Maritime &
Coastguard
Agency

English Channel Airspace Requirements – (ACP 2021 088)

Stage 2A: Options Development – Airspace Design Options
6 September 2023 [Revision 1].

Option 1A – Permanent Danger Area with a Danger Area Activity Information Service (DAAIS) Only

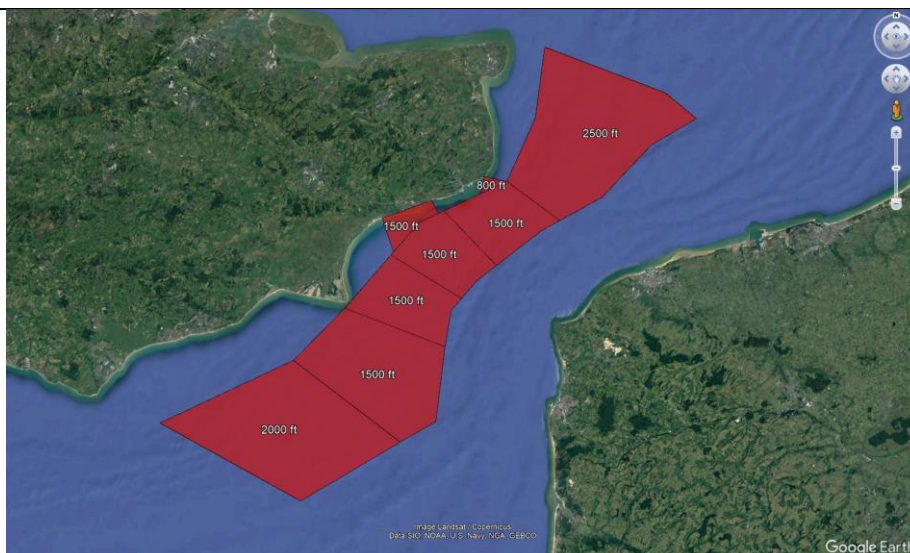
Description:
<ul style="list-style-type: none"> • A permanent danger area (DA) established in Class G airspace, within the Channel. • The same volume of airspace as the totality of TDA D098 complex, both laterally and vertically, with some amendments to the individual Danger Areas that make up the complex (please see design section below). • The option includes a DAAIS only.
Design:
<ul style="list-style-type: none"> • The same lateral and vertical dimensions as TDA D098 complex (and as set in the images below). • Danger Area active up to 365 days a year, until no longer required.

<p>Airspace Management:</p> <ul style="list-style-type: none"> • DAAIS provided: <ul style="list-style-type: none"> • 0830 – 1900 daily: Lydd APP 120.705. • 1901 – 0829 daily: London FIR 124.6. • All Operators (UAS & Manned) will need to notify Lydd ATC or London FIR dependent on time of day of the activity within the DA and work/monitor the RTF.
<p>Coordination:</p> <ul style="list-style-type: none"> • Daily check on planned activity (as now) with PPR for Lydd based UAS and manned SAR assets. • JRCC (ARCC) will continue to coordinate taskings within Danger Area (as currently). • All aircraft within DA will have to monitor frequency of service provider in line with time of day. • 123.1 would still be the discreet freq for UAS/UAS or UAS/SAR(H) / HMCG coordination / deconfliction, and in accordance with deconfliction plan. • GA Aircraft in distress (e.g. engine failure over Channel) given Cat A clearance priority, then SAR support.

<p>Modifications:</p> <ul style="list-style-type: none"> • Lydd APP freq DOC may need to increase to 40nm range to accommodate sector E. Important to retain existing frequency rather than an enforced channel change due to DOC requirements.
<p>Resourcing:</p> <ul style="list-style-type: none"> • Existing Lydd ANSP Certification/Designation sufficient for task. • Existing London FIR ANSP Certification/Designation sufficient for task.

Option 1B – Permanent Danger Area with DACS and DAAIS.

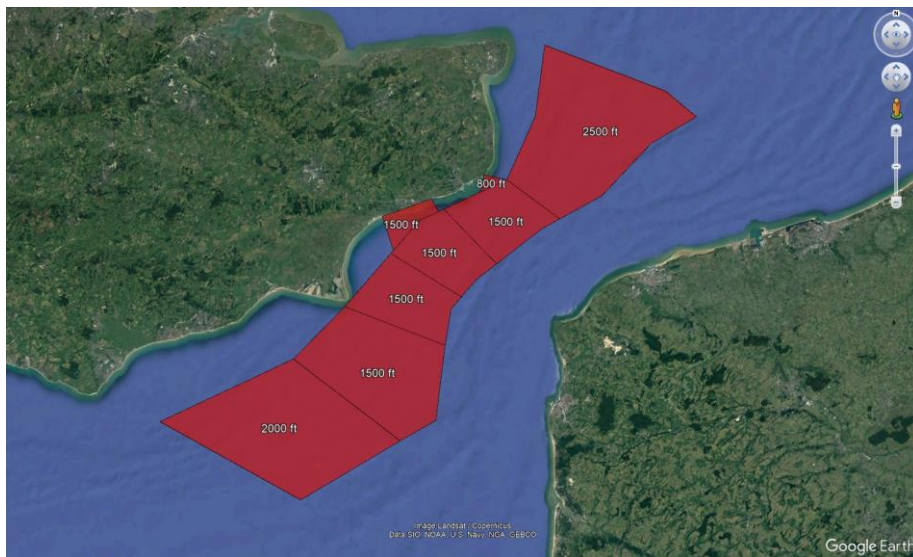
- The same lateral and vertical dimensions as TDA D098 complex (and as set in the images below)
- Danger Area active 365 days a year, until no longer required.

- H24/7/365 rather than activated /deactivated by NOTAM.
- Notification of the DAAIS/DACS Units within a note on the charted DA.
- Permanent charting will enable feed through to electronic flight mapping devices etc, enabling improved flight planning.
- This will reduce confusion over the activity, but the DAAIS/DACS enables flexible use of the airspace by all whilst facilitating more flexible UAS operations rather than to a pre-determined schedule.

- Daily check on planned activity (as now) with PPR for Lydd based UAS and manned SAR assets.
- JRCC (ARCC) will continue to coordinate taskings within Danger Area (as currently).
- All aircraft within DA will have to monitor frequency of service provider in line with time of day.
- 123.1 would still be the discreet freq for UAS/UAS or UAS/SAR(H) / HMCG coordination / deconfliction, and in accordance with deconfliction plan.
- GA aircraft requesting transit of Danger Area will make request on Lydd APP. Lydd Controller will check position of the various UAS (i.t.o Sector) and intentions. If inactive sector available for GA crossing, then this can be accommodated providing the higher priority SOLAS UAS or SAR(H) flight is not impeded.
- GA Aircraft in distress (e.g. engine failure over Channel) given Cat A clearance priority, then SAR support.

- Lydd APP freq DOC may need to increase to 40nm range to accommodate sector E. Important to retain existing frequency rather than an enforced channel change due to DOC requirements.
- ADS-B FID trial summer 2023 – not essential for DAAIS as described above, but will enhance SA and improve airspace management.
- VHF direction finder will need to re-instated to improve situational awareness for airspace management purposes.
- MATS2 update will be required, but procedures similar to D044/D141.

Option 2 – Permanent Danger Area with Corridors 24

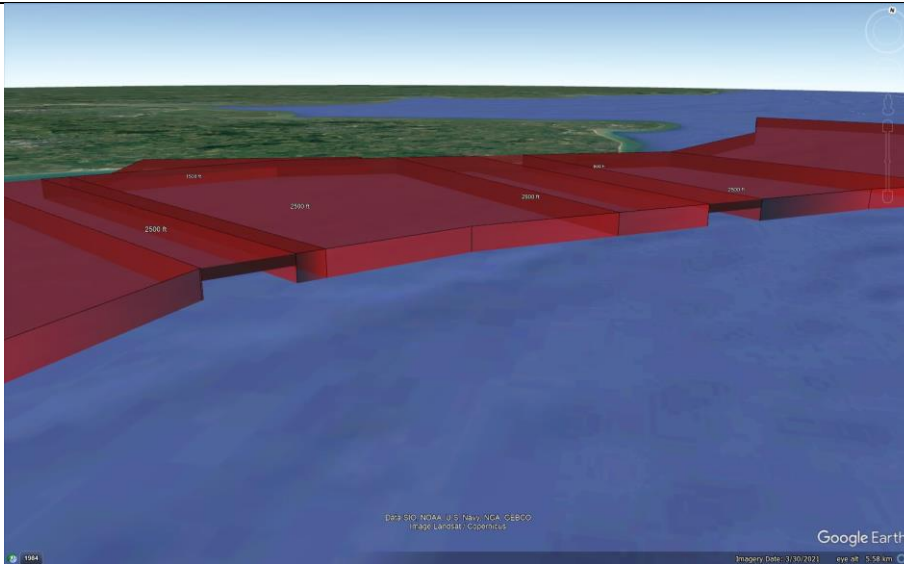
- The same lateral dimensions as TDA D098 complex (and as set in the images below).
- Two one-way corridors across the DA to facilitate GA cross below 1500ft.
- Danger Area active 365 days a year, until no longer required.

- Daily check on planned activity (as now) with PPR for Lydd based UAS and manned SAR assets.
- JRCC (ARCC) will continue to coordinate taskings within Danger Area (as currently).
- All aircraft within DA will have to monitor frequency of service provider in line with time of day.
- 123.1 would still be the discreet freq for UAS/UAS or UAS/SAR(H) / HMCG coordination / deconfliction, and in accordance with deconfliction plan.

- Lydd APP freq DOC may need to increase to 40nm range to accommodate sector E. Important to retain existing frequency rather than an enforced channel change due to DOC requirements.
